EXPEDITED
MONTGOMERY COUNTY HISTORIC PRESERVATION COMMISSION
STAFF REPORT

Address:	931 Ellsworth Drive, Silver Spring	Meeting Date:	12/18/2019
Resource:	Master Plan Site #36/07 (Silver Theatre and Shopping Center)	Report Date:	12/11/2019
Applicant:	Bob Biroonak	Public Notice:	12/4/2019
Review:	HAWP	Tax Credit:	N/A
Case Number:	36/07-19A	Staff:	Michael Kyne
PROPOSAL:	Signage installation

Fig. 1: Subject property, with front (east) and rear (west) entrances labelled (provided by applicant).

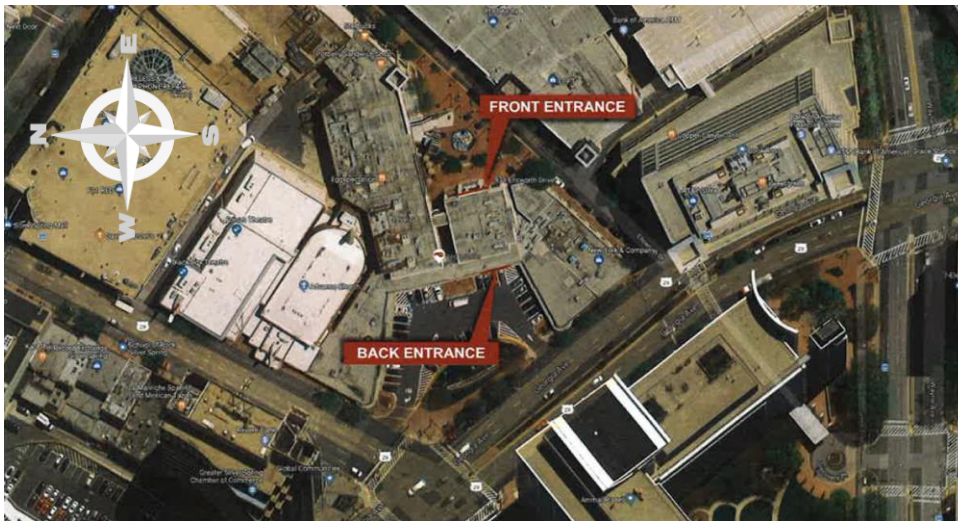
The applicant proposes to install internally lit signage at the front (east) and rear (west) entrances of the subject property. Vinyl graphic signage will also be installed on the building's rear (west) windows.

- Any required mounting hardware (i.e., bolts) will be installed in the masonry joints, not directly into the limestone.

Tenant Signage Plans dated October 24, 2019 are attached and approved with notes, with total area of 96 sq. ft.

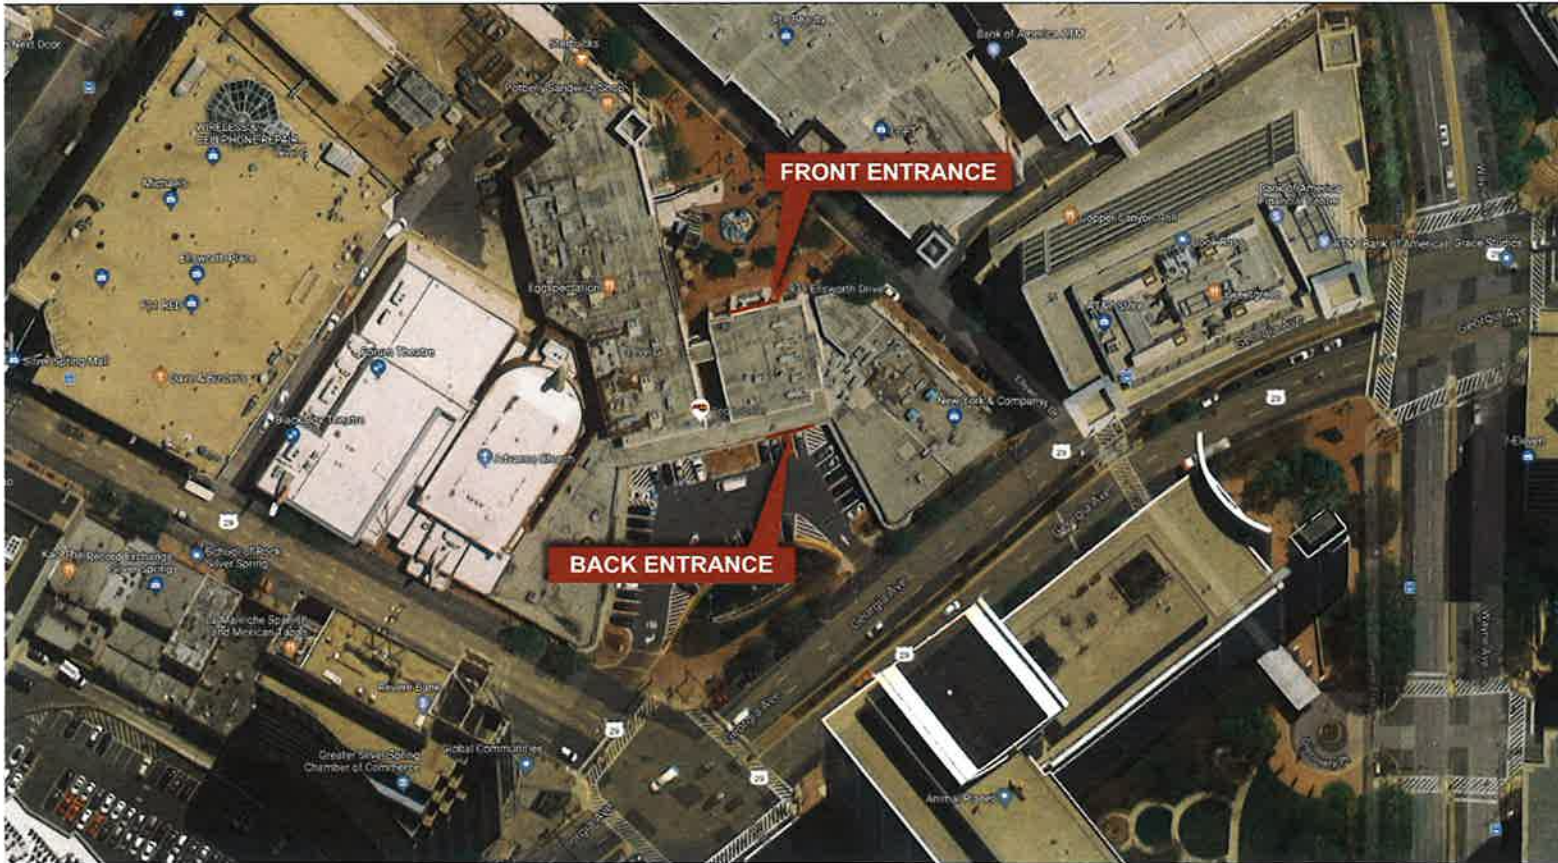
Enclosed is a copy of the exterior signage marked "Approved as Noted". It is necessary that you ensure all building penetrations are properly sealed from all elements. Please attach this to your signage permit application packet to Montgomery County.
